<b>Docket Number:</b>	15-RETI-02
<b>Project Title:</b>	Renewable Energy Transmission Initiative 2.0
<b>TN #:</b>	215228
<b>Document Title:</b>	Clean Coalition Comments on RETI 2.0 Plenary Report
<b>Description:</b>	N/A
<b>Filer:</b>	System
<b>Organization:</b>	Clean Coalition
<b>Submitter Role:</b>	Public
<b>Submission Date:</b>	1/10/2017 9:14:56 PM
<b>Docketed Date:</b>	1/11/2017

**CLEAN COALITION WRITTEN COMMENTS ON THE RENEWABLE ENERGY  
TRANSMISSION INITIATIVE 2.0 PLENARY REPORT**

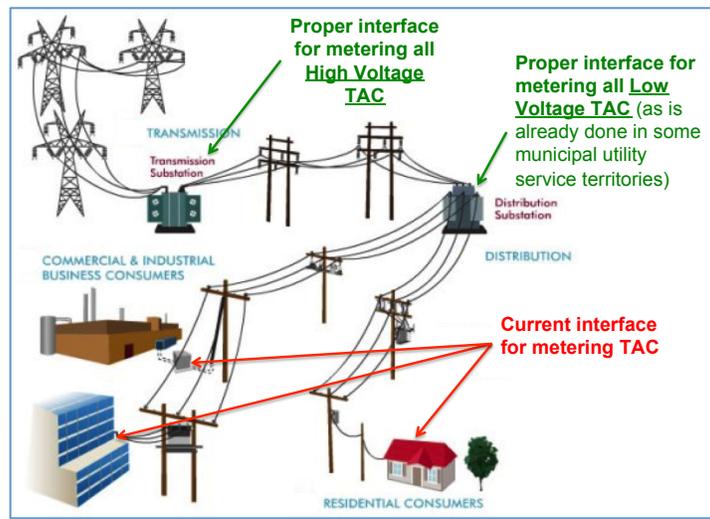
Despite the benefits mentioned above, distributed generation (“DG”) resources—particularly local renewables—face a massive market distortion that skews the market against them. Transmission Access Charges (“TAC”) are usage fees designed to pay for California’s transmission system, including investment amortization, return-on-equity, operations, and maintenance. TAC add nearly 3¢/kWh to the levelized cost of energy over a typical 20 year renewable energy contract, increasing the wholesale price

of energy in California by about 30%. **TAC are currently misapplied to local energy that does not actually use the transmission grid, including local renewable energy.** The RETI 2.0 effort should be aware of this issue and consider that the demand for additional transmission projects to meet RPS and GHG goals may be overstated due to the TAC distortion’s impact on DG resources.

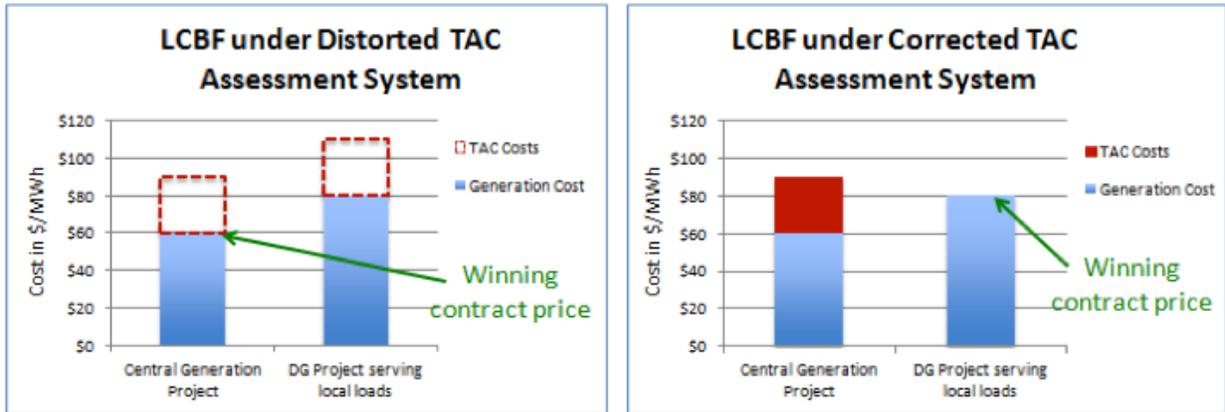
The current method for assessing TAC causes local generation to subsidize costs associated with the transmission grid, distorting Least Cost Best Fit (“LCBF”) conclusions when comparing local generation to centralized generation. The charts below compare distorted LCBF conclusions (left chart)

against corrected conclusions (right chart). This market distortion harms ratepayers by discouraging the development of cost-effective local renewable energy resources, depriving communities of the benefits of local energy development, and artificially inflating demand for transmission capacity.

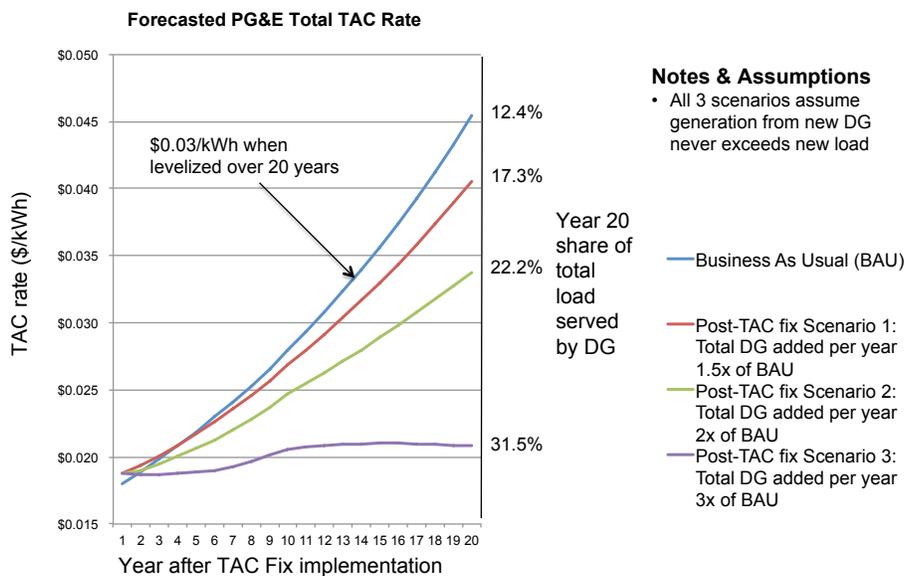
Measuring TAC at substations in all service territories will provide consistent TAC treatment across the entire CAISO region and ensure accurate market signals. The elimination of the massive TAC market distortion will result in increased deployments of local generation, which will significantly reduce TAC over time and save ratepayers enormously. The Clean Coalition estimates that a solution to the TAC distortion will increase the amount of local renewables by a factor of 5 and save California ratepayers approximately \$40 billion in avoided transmission costs over 20 years. The chart below shows drastically reduced TAC rate outcomes over 20 years by eliminating the TAC market distortion. The area between the blue and purple curves represents over \$20 billion in avoided transmission costs over 20 years.
